New Stormwater Design for Graeme Brown,
116 Richard Street, Opotiki.

Building Consent Application Number 4293
Owner: Mr Graham Mervyn Brown

Proposal: Resiting a second hand dwelling onto a new timber pile foundation as outlined in plans attached.

116 Richard Street Stormwater System

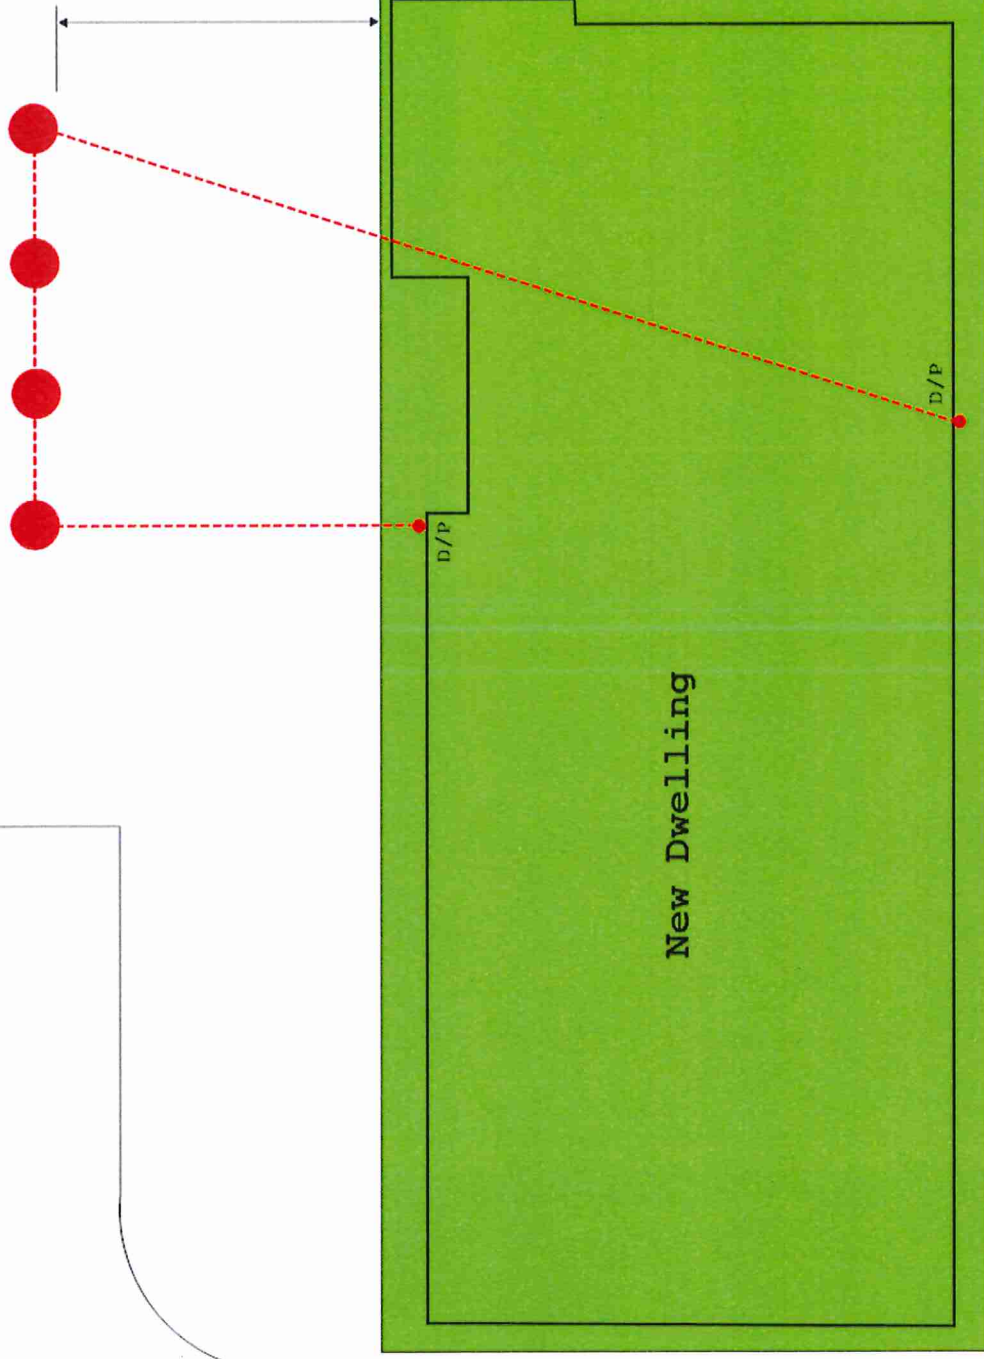
6. Please provide soakage calculation for pit sizing.
Taken from the Geotech Report.
 - Soakhole depth should be limited to 0.9m depth.
 - Soakholes should be located at least 4m away from building foundations.

8. No calculations have been provided to determine the soakhole sizing. Please provide this based on the information provided in the geotech report.
soakhole info

Total Number of Soak Holes Required = 4

Depth of Each Soak Hole = 900mm + 200mm
drainage metal below each hole as per plan supplied

4 - 900mm x 900mm Soakholes interlinked together

4 - 900mm x 900mm
Soakholes laid in
series as per plan
